Meeting: 11/20/2025
Applicant: Devon Rodriguez, Red Door Homes of East Tennessee
Owner: Richard and Miranda Brewer

Location: 700 Morgan St. **Parcel ID** 94 D J 029
District: Fourth and Gill H
Zoning: RN-3 (General Residential Neighborhood)
Description: N/A
Vacant lot.

Level III Construction of New Primary Building

7-G-25-HZ
APPLICATION FOR CERTIFICATE OF APPROPRIATENESS

**STAUB, VANGILDER &
HENDERSON'S ADDITION
TO KNOXVILLE - LOT 247R
700 MORGAN ST, KNOXVILLE, TN 37917**

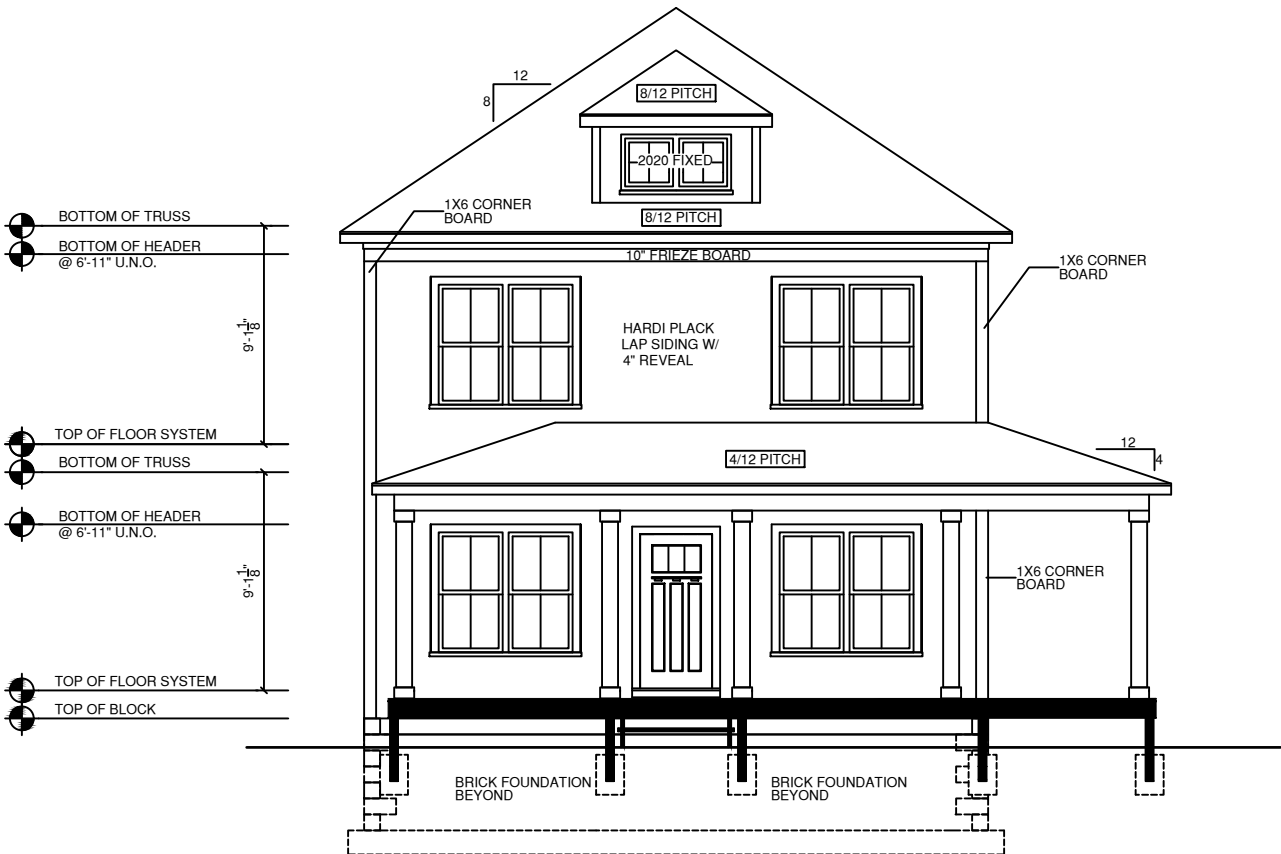
3. The average front setback of the blockface is 16' (approximately 12' to the front porches), and the adjacent house at 704 Morgan Street is set 17' from the front property line, with a corner porch that's flush with the main massing. The proposed setback measures 16' to the full-length front porch, with the main massing set 23' from the front lot line. The house will be placed slightly further from the street than most of the buildings on the block but will be generally aligned.

The 10.5' interior side setback is consistent with the historic development pattern. Most corner lots in Fourth and Gill have smaller corner side setbacks than the proposed 17.5' or the 12' required by the zoning code, typically ranging between 5'-13'. The large corner side setback is driven by a slightly narrower house form. The Commission should discuss whether the front and corner side setbacks are compatible with the context.

4. The proposed parking is a concrete pad at the rear of the lot and is accessed via the alley, which will preserve the existing streetscapes along Morgan Street and E. Fourth Avenue by avoiding curb cuts and reducing visibility. The final site plan should meet City Engineering standards, with minor revisions to be approved by staff.

Front Elevation

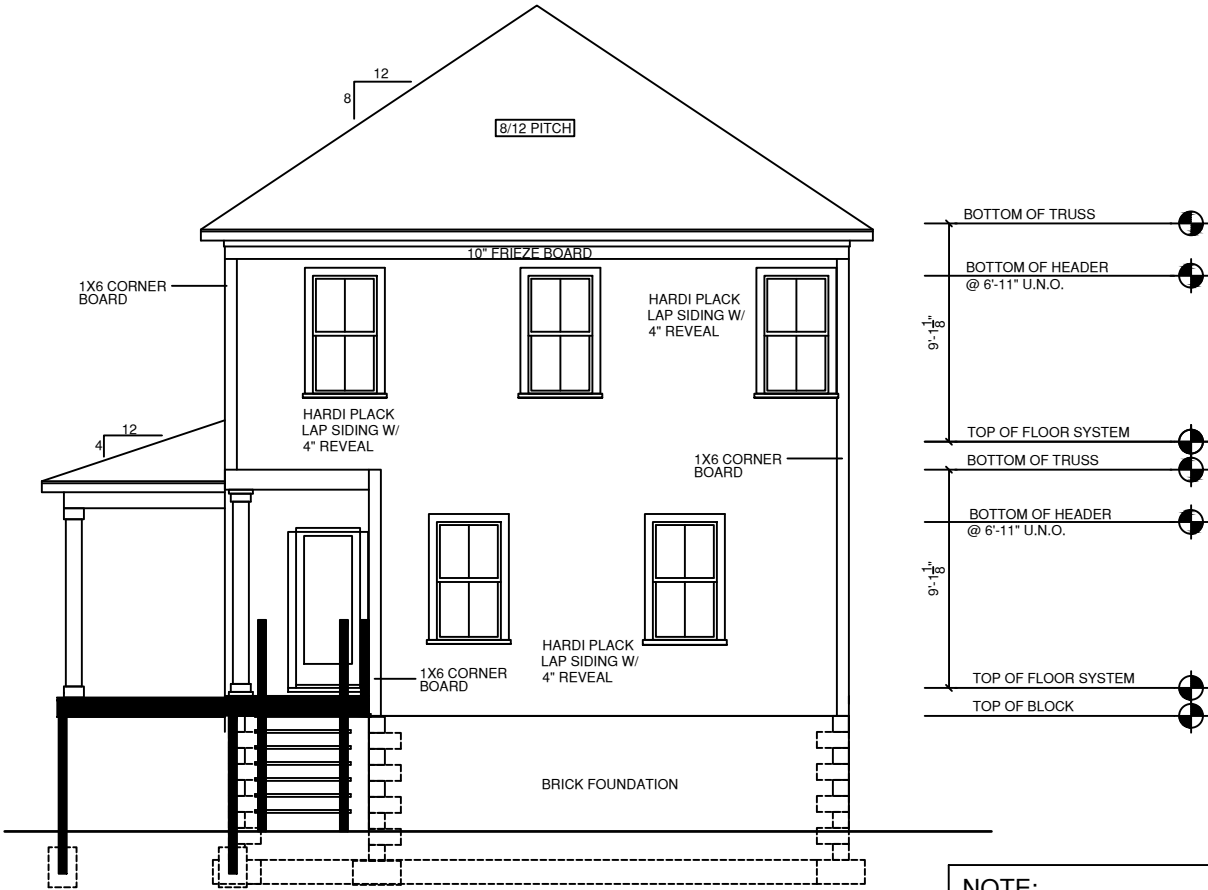
The façade (southwest) features three bays, with paired 3/1 double-hung windows on each story of the left and right bays, flanking a quarter-lite wood paneled door on the first story. The right elevation features three irregular bays of 3/1, double-hung windows on both the first and second stories, with the front-porch wrapping around the front corner and a deck with a wood handrailing recessed under the primary roofline at the rear corner with a full-lite door. The left elevation features two and a pair of 3/1 double-hung windows on the second story and three 3/1 double-hung windows on the first story. The rear elevation features three 2/2 double-hung windows on the second story, and there are two 2/2 double-hung windows and a secondary entrance with steps leading to the deck on the first-story. All windows will be made from fiberglass-clad wood or aluminum-clad wood (Marvin Elevate “wood clad” product), and the window profiles on the elevation drawings and renderings conflict, with the drawings showing 2/2 windows in the place of the 3/1 windows.

8. The façade features a full-length, wrap-around 6'-8" deep front porch with 8" square columns (material unspecified but likely wood) and will be accessed via full-length brick steps. The proposed front porch is compatible with the dimensions of the house and other porches on the block, and it meets the minimum depth recommended by the guidelines. The wrap-around porch is similar to that of the previous structure on the site and provides additional interest to the highly visible right elevation. The tongue-and-groove flooring is appropriate, and the final drawings should include a handrailing if required by code, ideally a wood handrailing with balusters set in the top and bottom rails. The porch columns have been revised from Craftsman-style tapered columns with wood bases, but they are similar to those on other houses on the block. The materials for the porch columns and ceiling should be included in the final drawings, and the porch columns should feature trim at the top and base.

- 1) final site plan to meet City Engineering standards;
 - 2) final material specifications for the roofing, secondary entrances, porch columns, and porch ceiling to be approved by staff and included in final drawings;
 - 3) the porch columns to feature trim at the top and base, as depicted;
 - 4) the projecting sills, trim on the windows to be retained, and the windows to use simulated divided lites;
 - 5) the final drawings to depict the foundation height and front steps as-built and a handrailing on the front porch if required by code, to be approved by staff;
 - 6) the placement of the window and door on the right elevation to be aligned; and
 - 7) a beltcourse with the same color as the window trim be introduced to divide the stories.
-

Rear Elevation

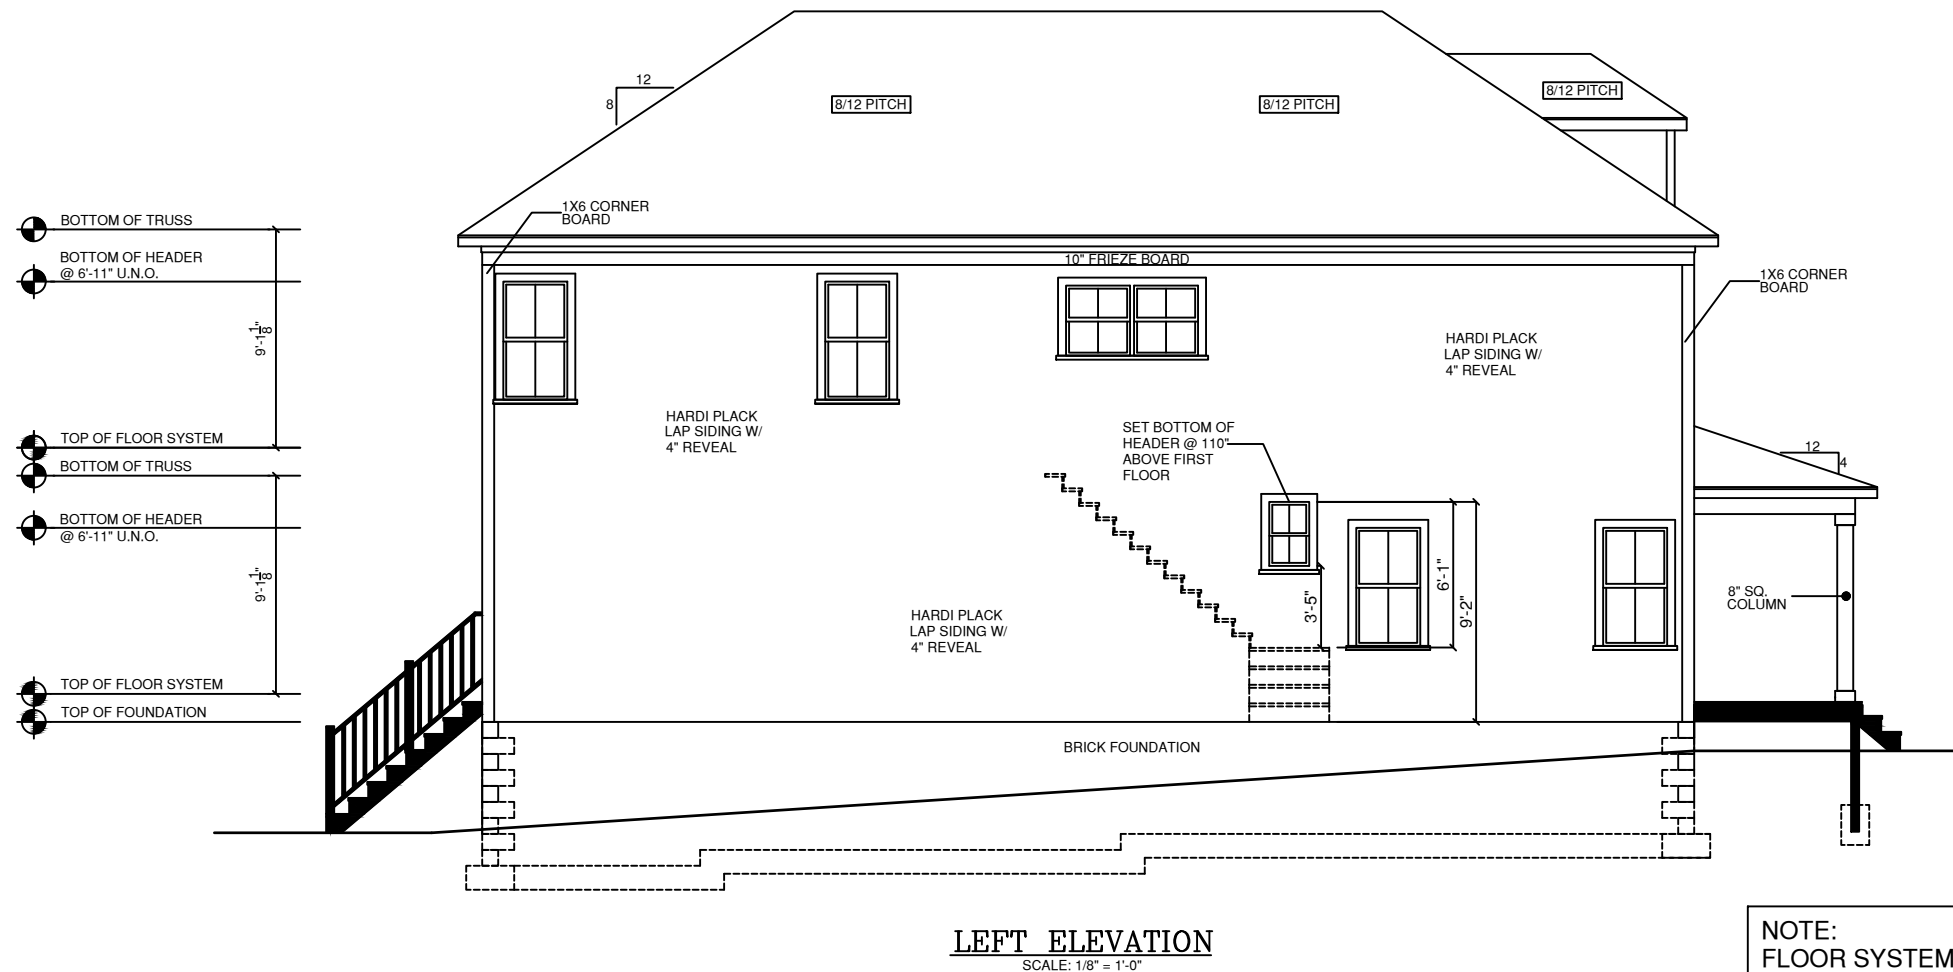
9. Guidelines recommend "break[ing] up uninteresting boxlike forms into smaller, varied masses" organized into bays and using a "mix of wall areas with door and window elements" like those found on existing buildings. The façade achieves this with its consistent bays, hipped roof dormer, and full-length front porch. Although the number of windows and their placement have been revised, the side and rear elevations are not organized into bays that are compatible with historic forms, and the side elevations feature large swaths of blank siding. The side elevations will be highly visible due to the house's narrow width and placement on a corner lot. The placement of the window and secondary entrance on the right elevation should be aligned. The Commission should discuss whether additional windows should be added to the side elevations, whether the right elevation has sufficient interest for its visibility, and whether the window placement on the rear elevation should be aligned.

RIGHT Elevation

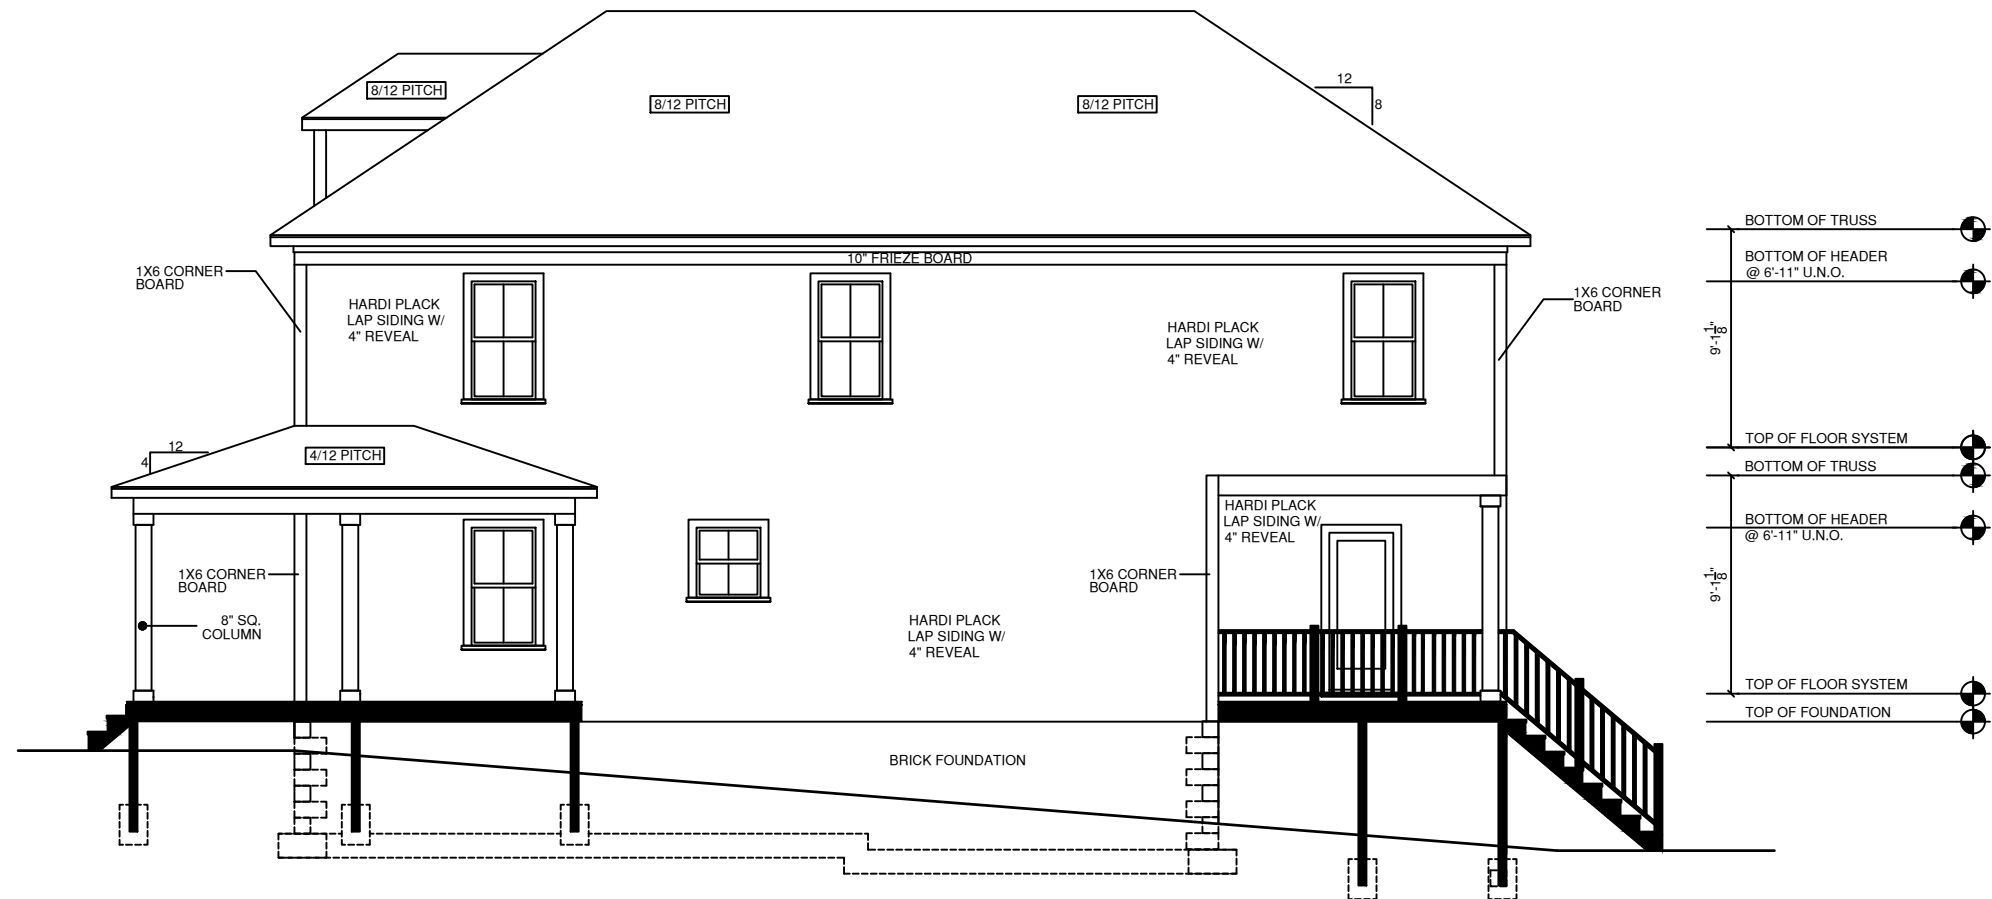
11. Guidelines recommend that windows on new construction be similar in material, operation, and muntin profile to historic houses in the neighborhood. The design primarily features 3/1 (on renderings but 2/2 in elevation drawings) double-hung fiberglass-clad wood or aluminum-clad wood windows, which are appropriate for Craftsman styling and use proportions that will differentiate the house from the historic buildings on the block. The windows feature projecting sills and trim that should be retained, and the final windows should feature simulated divided lites, to be approved by staff. However, the design features six different window sizes and irregular placement on the side elevations; the Commission should discuss if the window sizing and placement on secondary elevations is appropriate.

12. Guidelines recommend that materials for new buildings be consistent with materials on the street. Brick cladding on the foundation is appropriate; the applicant should submit a section indicating the brick foundation aligning with the face of the siding above, instead of protruding outwards from the siding. The proposed siding is fiber cement lap siding with a smooth finish and 4" reveal, which has been approved on new construction in Fourth and Gill. Different siding colors are proposed for the first and second stories, and a beltcourse with the same color as the window trim should be introduced to divide the stories.
